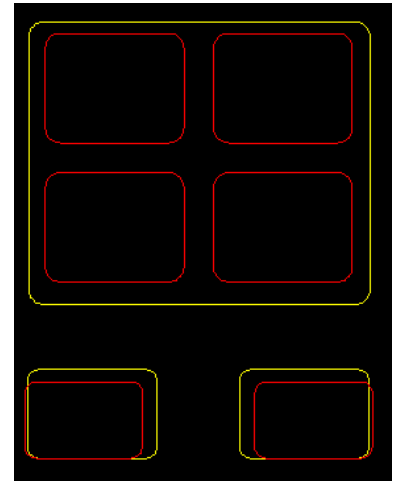
Customer was having various issues with LED device, their message was: **“The current stencil design as per manufacturer recommendation but still create a lot defects (Solder Bridge, Solder Balls, Component Tilt, Skew... etc.)”**

I recommended the design shown in the picture to the right (Red pads are stencil Apertures and Yellow ones are SMT Pads).

The 4 windows would help getting a uniform distribution of paste volume underneath the large pads, instead of centering solder in the middle using one brick, as that what might be causing the tilt & skew. With four bricks, solder would wet uniformly and not cause such defects.

For the terminal apertures, I recommend reducing the size of the apertures to reduce the volume of solder paste, and to move them apart to reduce the possibility of bridging, also to shift the apertures downward to help eliminating solder balls of being formed underneath the chip.

The stencil design is working fine.

There was 20% void on the LED's large aperture but meet the customer specification.

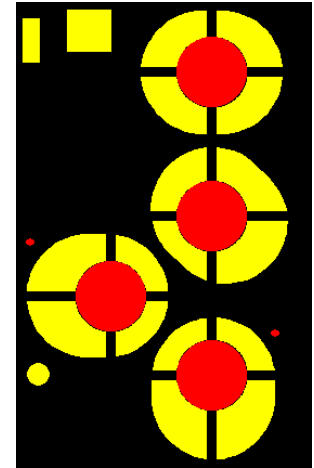
Customer stated that their product historically had insufficient solder fill on the pogo pins at some connector locations. Their old stencil was 5 mil and the aperture was cut 1:1. They wanted to redesign the bottom side stencil (where the pins are placed) to have 100% fill solder of the barrels and try to eliminate the touchup that was required for their assembly.

100% barrel fill is very hard to achieve as it would require very big apertures or too thick stencil, and considering the other components around the through hole components in this assembly the only option would be to use a step up stencil.

The other issue with this assembly is that the pins are too wide and pushing solder paste through the barrel to the other side of the PCB, for such application we may use a wagon wheel design to not print over the pins.

For PIP applications the stencil should print double the required solder paste volume as solder paste is 50% solder powered and 50% flux. To get 100% barrel fill, the stencil needs to be stepped up to 10mil thickness for the area where the connectors are, and to enlarge the apertures by 40% more than the old stencil aperture. Due to the very big apertures, the location of them needs to be shifted to maintain at least 15mil gap.

The image to the right shows the recommended stencil apertures (Yellow) aligned with the through hole pads (Red)

I'm please to share with you all that the recent stencil you designed and provided to us was a great success! I'm including a picture of the new stencil results, as you can see, the new stencil achieved what we had hoped for (complete barrel fill). There were no other issues reported with the other locations and the production team is quite happy that they no longer are required to touchup these assemblies. Great job and thank-you very much!
